REQUEST FOR INFORMATION	DATE: May 16, 2017	NO.: RFI-542
--------------------------------	---------------------------	---------------------

Project Name: 15051-Webster University Interdisciplinary Science Building	Project No.: 15051
---	--------------------

Subject: Boiler and hot water flue roof penetration detail

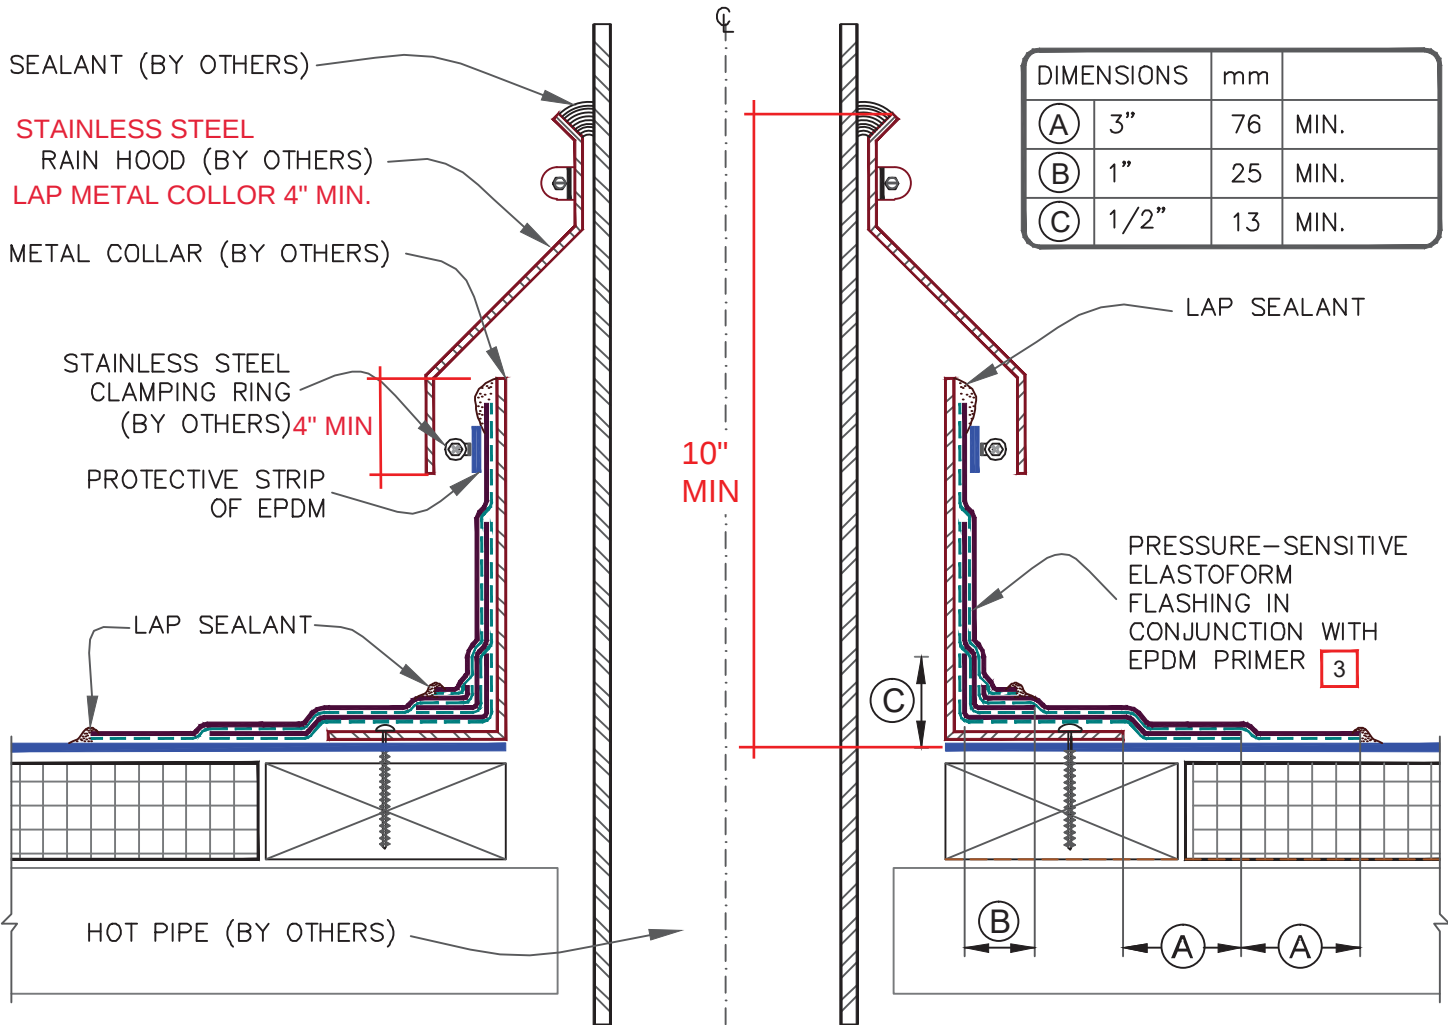
The boiler and hot water flues will penetrate the roof (see attached photo and markup) please provide desired penetration detail.

Please see attached Carlisle SynTec Field Fabricated Hot Stack detail U-8D. KWA has add notes for stainless steel rain hood must lap metal collar 4" min. Detail must comply with manufactures requirements for 25 year warranty.
